Serial No.: 10/065,516

For: METHOD OF DETECTING CRACKS IN JET
PUMP BEAMS OF A NUCLEAR REACTOR

REQUEST FOR APPROVAL OF DRAWING CHANGE

FIG. 6

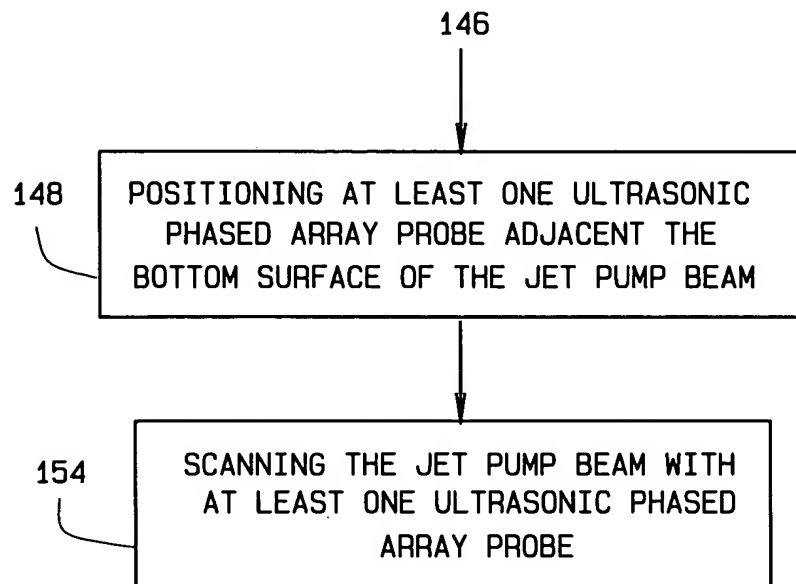
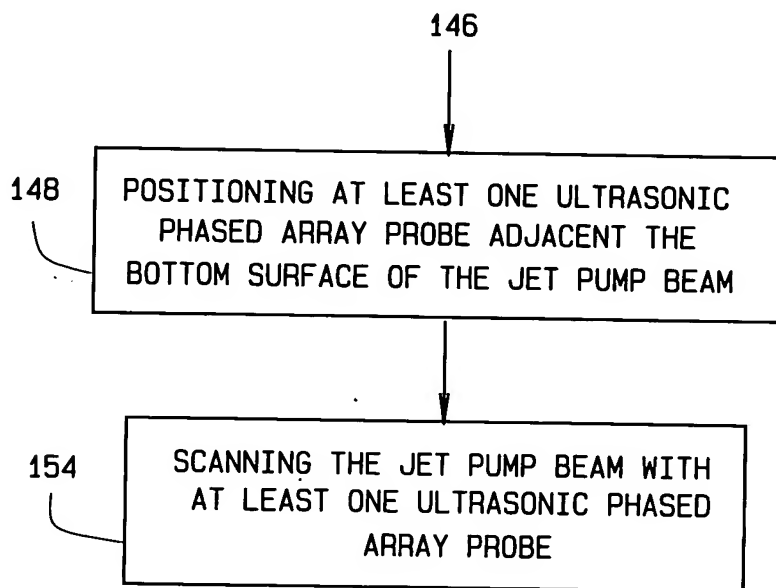
In response to the Notice To File Corrected Application Papers, submitted herewith are two (2) sheets of drawings showing changes to the labeling of the second Figure 5 and Figure 6 in the above referenced patent application. Specifically, the second Figure 5 has been relabeled as Figure 6, and the original Figure 6 has been relabeled Figure 7.
